**Subject: Beaver Valley Power Station, Unit No. 1 and No. 2
BV-1 Docket No. 50-334, License No. DPR-66
BV-2 Docket No. 50-412, License No. NPF-73
Response to a Request for Additional Information in Support of
License Amendment Requests Nos. 317 and 190**

REQUEST FOR ADDITIONAL INFORMATION
RELATED TO FIRSTENERGY NUCLEAR OPERATING COMPANY (FENOC)
BEAVER VALLEY POWER STATION, UNIT NOS. 1 AND 2 (BVPS-1 AND 2)
CONTAINMENT CONVERSION TO ATMOSPHERIC CONDITIONS
DOCKET NOS. 50-334 AND 50-412

Sensitivity of Containment Pressure to LOCA Airborne Water Fraction

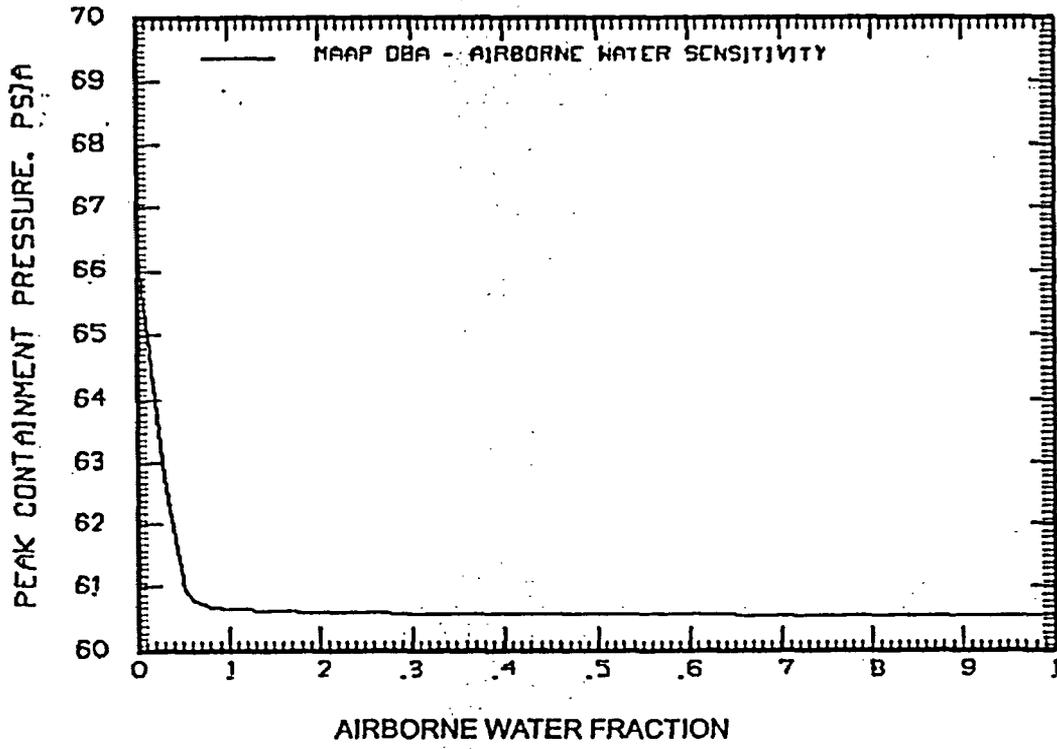
14. Enclosure 2 Section 4.2.1: (a) Describes the modeling of the droplets formed by 10% of the nonflashed break flow. Include entrainment, gravitational settling, impaction on solid surfaces, coalescence, vaporization and condensation. (b) What is the basis for the assumed 100 micron droplet size for break flow? (c) What is the basis for the 10% fraction of the non-flashed flow which is droplets?

MAAP-DBA credits water droplets originating in the blowdown jet into the containment atmosphere following LOCA. During and following a blowdown transient, airborne water acts as an internal distributed heat sink for steam to minimize superheat as well as to condense some of the steam mass. With the large surface-to-volume ratio, combined with high water density and specific heat compared to steam, a relatively small droplet water mass is sufficient to eliminate steam superheat from the containment atmosphere. During the blowdown, the fraction of available liquid airborne is specified to be 10% with a droplet size of 100 microns. Following blowdown (about 30 seconds or less) the fraction of available liquid airborne is specified as 0%, and the remaining airborne water mass decreases due to deposition, potentially spray operation, or evaporation. The deposition is calculated with the models in the FPTRAN sub-routine as described in the MAAP4 User's Manual. The deposition mechanisms addressed in this sub-routine include sedimentation, impaction, containment leakage, diffusiophoresis, and thermophoresis. Evaporation is calculated with the models described in Section 2.1.1.6 of the pre-submittal report (FENOC Letter L-03-188, L. W. Pearce dated November 24, 2003, Subject: Beaver Valley Power Station, Unit 1 and 2, BV-1 Docket No. 50-334, License No. DPR-66, BV-2 Docket No. 50-412, License No. NPF-73 Containment Conversation Pre-Application Report).

The droplets generated at the break during blowdown will be on the order of 100 microns or less based on measurements for discharge of superheated (relative to the discharge environment) water. Other containment analysis codes such as GOTHIC also use this drop size. GOTHIC's quantification analyses performed using a drop size of 100 microns were found to agree with and typically bound the measured pressure and temperature response for blowdown tests and measured pressure drops from orifice pressure drop tests.

The bases for the 10% fraction of the nonflash flow which is droplets include integral effects containment experiments and sensitivity analyses. The CASP1 (D15) and CASP2 (D16) experiments performed in the Battelle-Frankfurt model containment (as discussed in 9.4.3) show the aerosolization and airborne transport of water during blowdown. Assessments of the results for these two tests indicate values of 49% and 65% for the water masses transported as liquid outside of the break room. Consequently, these experiments undergoing a high pressure two-phase critical discharge clearly have a large fraction of water transported away from the break room. It is also noted that these experiments were performed with an impingement (baffle) plate immediately downstream of the break, which acts to strip-out (reduce) the airborne water mass. These results demonstrate that the assumed airborne fraction of 10% used in the BVPS-1 and -2 containment conversion analysis is a conservatively low value. Additionally, the pre-submittal report (FENOC Letter L-03-188) provided by FENOC presented a sensitivity of containment pressure to LOCA airborne water fraction using the MAAP-DBA code and the single node model. The MAAP-DBA code single node model using the Tagami heat transfer correlation was run for a series of assumed airborne water fractions. For airborne water fractions of 0.1 to 1 the calculated peak containment pressure was shown to be insensitive as shown in the following figure.

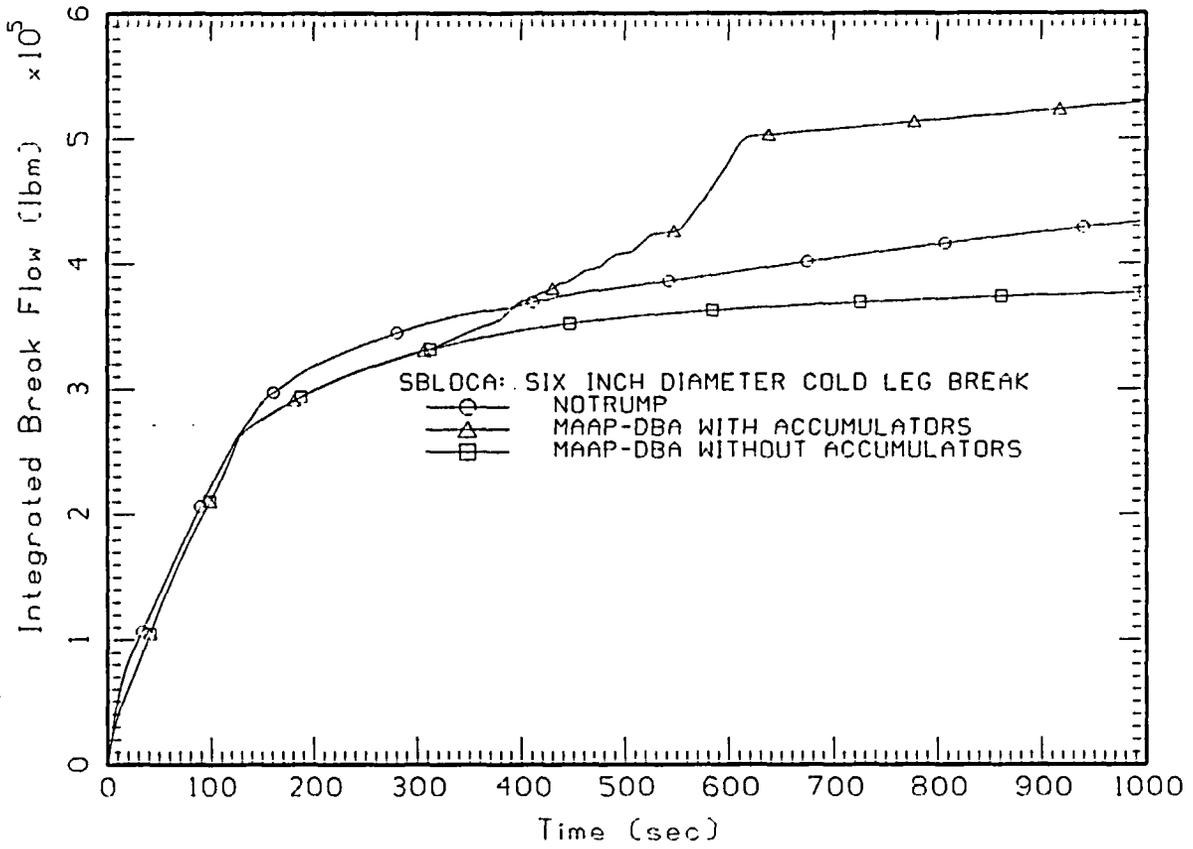
19. Enclosure 2 Figure 9-29a: Explain why the two curves shown in the figure diverge significantly beginning around 400 seconds.

The two curves shown in Enclosure 2 Figure 9-29a indicated the integrated break flow (lbm) for the MAAP-DBA and NOTRUMP 6 inch diameter cold leg break. The two curves diverge significantly beginning around 400 seconds due to the difference in the simulated performance of the accumulators and the impact of the injected water on the primary system conditions. The MAAP simulation indicates a higher integrated mass flow rate since the accumulator is calculated to have completely discharged its inventory into the primary system. By approximately 825 seconds the accumulator is completely depleted in the MAAP-DBA simulation and partially depleted in the NOTRUMP simulation. The attached figure includes a third curve, which was calculated with MAAP-DBA with the accumulators disabled. The two sets of MAAP-DBA results bracket the NOTRUMP prediction and illustrate the impact of completely depleting the accumulator inventories in the MAAP-DBA prediction.

Figure 1: PWR primary system nodalization for Westinghouse design.

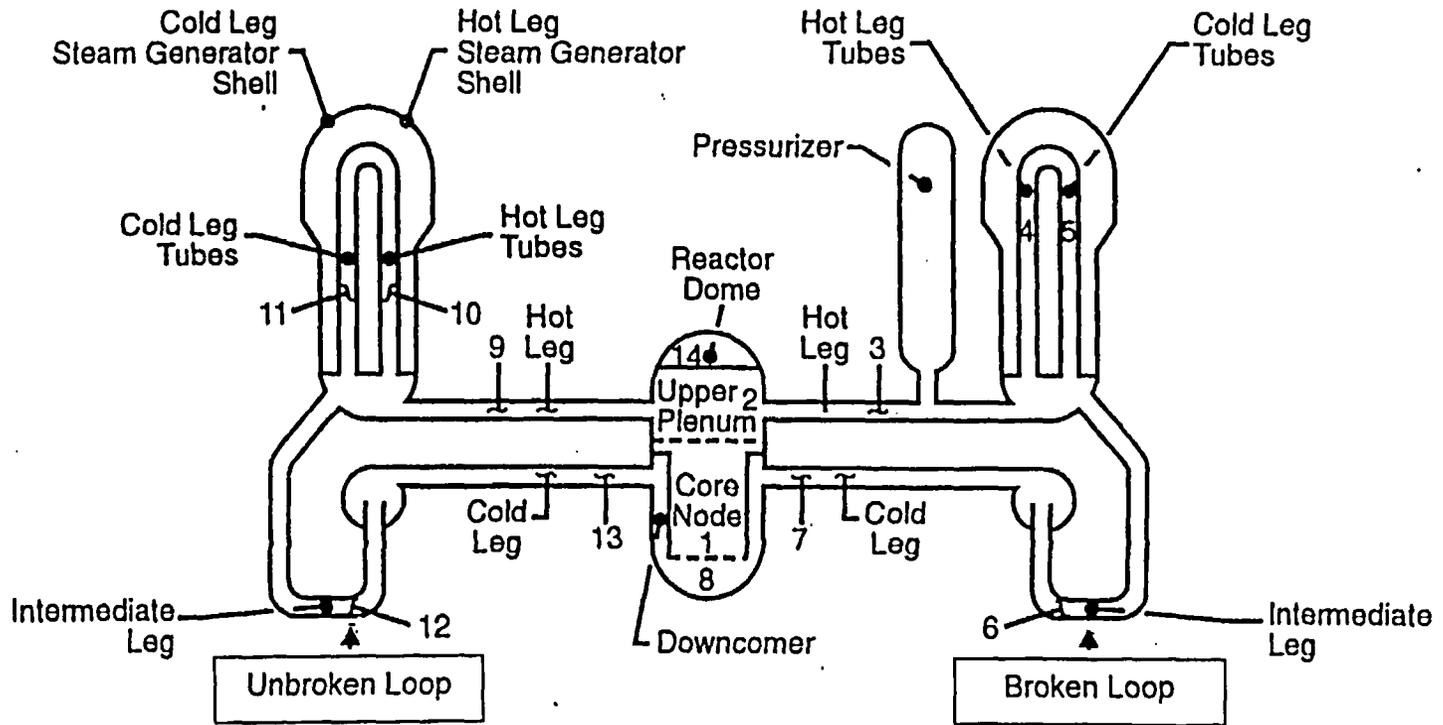
20. Enclosure 2 Section 9.5: (a) Describe the MAAP-DBA model used for the small break mass and energy release calculations. (b) Provide a nodding diagram for the MAAP-DBA small break analyses. (c) Describe the break flow model used and the C_D value used. (d) Provide results of coolant level vs. time for the 2-inch and 6-inch Beaver Valley-specific small break calculations. (e) Explain why, although the MAAP-DBA model will be used for breaks up to 12 inches, no benchmarks are done for breaks greater than 6 inches. (f) MAAP-DBA is benchmarked against NOTRUMP for SBLOCA mass and energy release. Neither code has the capability to model multi-dimensional and entrainment effects (e.g., emergency core cooling bypass and asymmetric downcomer boiling). Please explain why it is acceptable to neglect these effects when calculating break flow for the larger small breaks.

Part (b) - Figure 1 provides the nodding diagram for the MAAP-DBA LOCA analyses. Note that the loop with the pressurizer is designated as the "broken loop" which has experienced the postulated pipe break, while the "unbroken loop" represents the two loops that are not postulated to have a pipe break.
